SAFETY RECALL BULLETIN

NHTSA RECALL 22V262

AUTOCAR, LLC SAFETY RECALL ACX-2202

Autocar, LLC has determined that a defect which relates to motor vehicle safety exists in certain Xpeditor (ACX) chassis. The hazard lamps will not function with the ignition off.

Figure 8

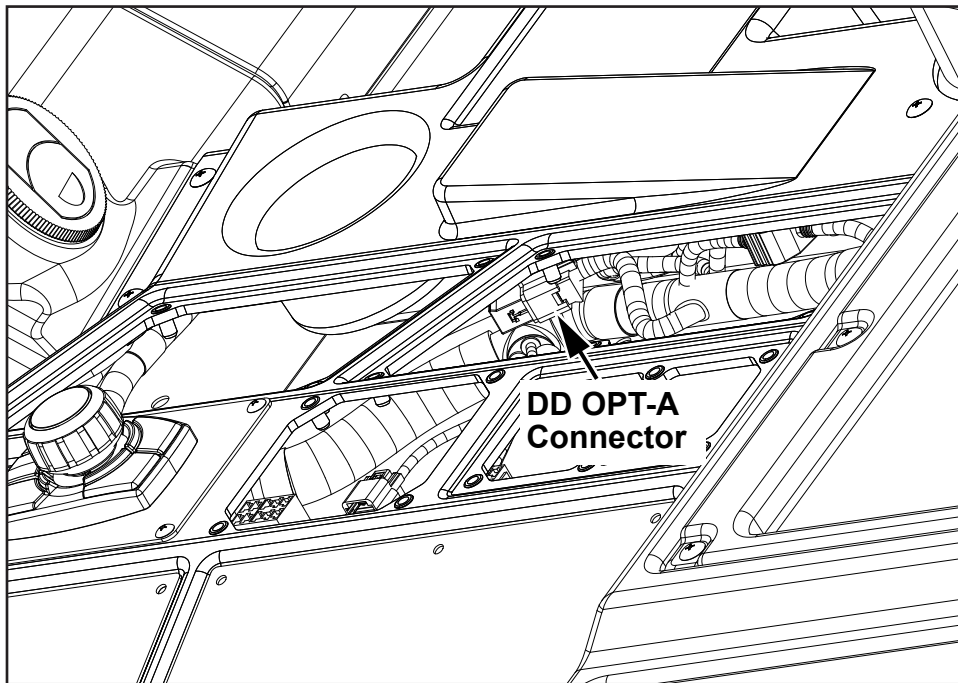
6. Locate the connector labeled "DD OPT-A" (see *Figure 8*).

Figure 9

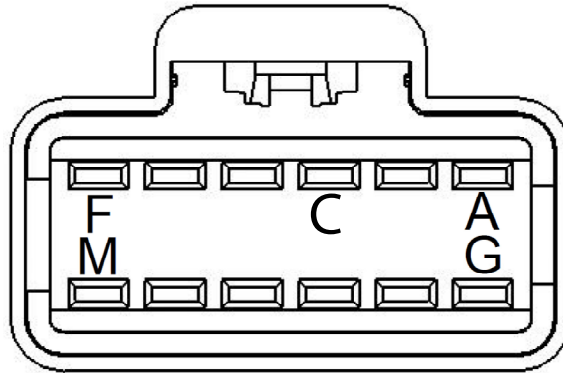
7. Remove the terminal in cavity C, insulate the terminal using SBHS-THS RED Heat shrink tube and secure with heat (see *Figure 9*).

Figure 10

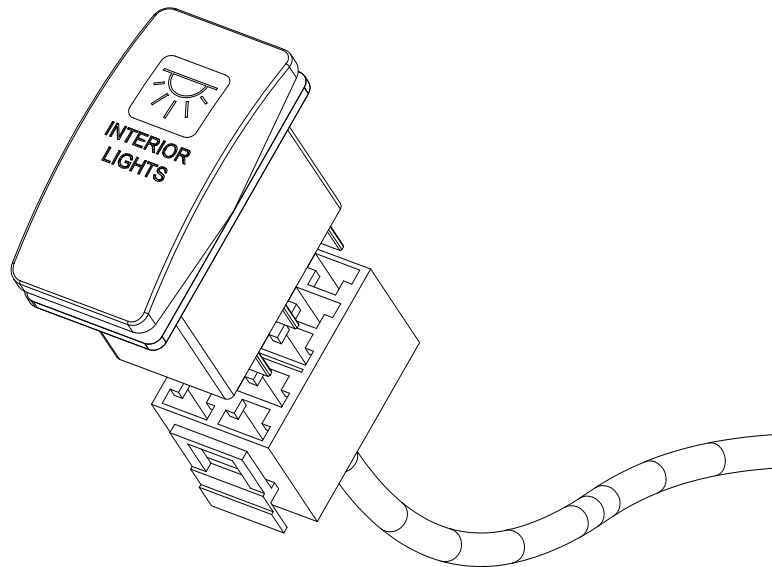
8. Disconnect the plug labeled "INTERIOR LT" from the interior light switch (see *Figure 10*).

Figure 11

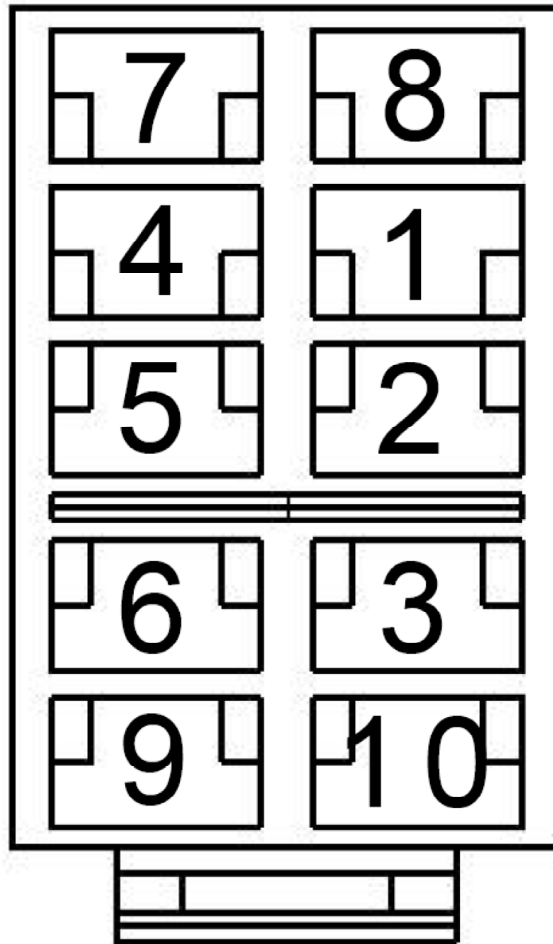
9. Remove the terminal from cavity 2, cut off and discard the terminal (see *Figure 11*).

Figure 12

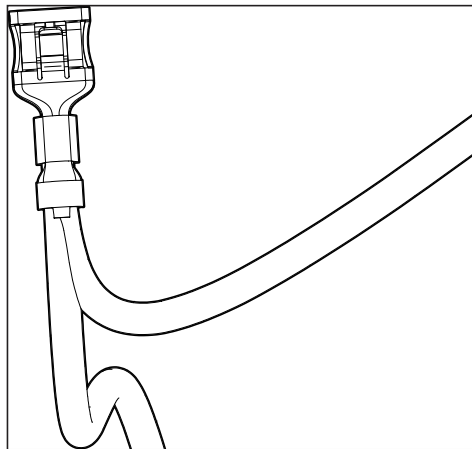
10. Strip 1/4" of insulation from the wire cut in step 9.
11. Using the S8731015-002 harness, locate the non-terminated wire and strip 1/4" of insulation from the wire.
12. Insert and crimp the stripped wires from steps 10 and 11 into the 12015870 terminal (see Figure 12).

13. Insert the crimped terminal from step 12 into cavity 2 of the “Interior Lt” connector.
14. Insert the remaining end of the S8731015-002 harness into Cavity C of the “DD OPT-A” connector.
15. Reconnect “DD OPT-A” and “Interior Lt”.
16. Route and clip all harnesses to verify there are no rubbing or chafing concerns.
17. Reinstall all panels using the fasteners set aside in step 4 and 5.
18. Turn on the battery disconnect switch or re-connect the battery cables beginning with the positive connections followed by the negative connections.
19. Refer to Section I for function testing.
20. Installation is complete.
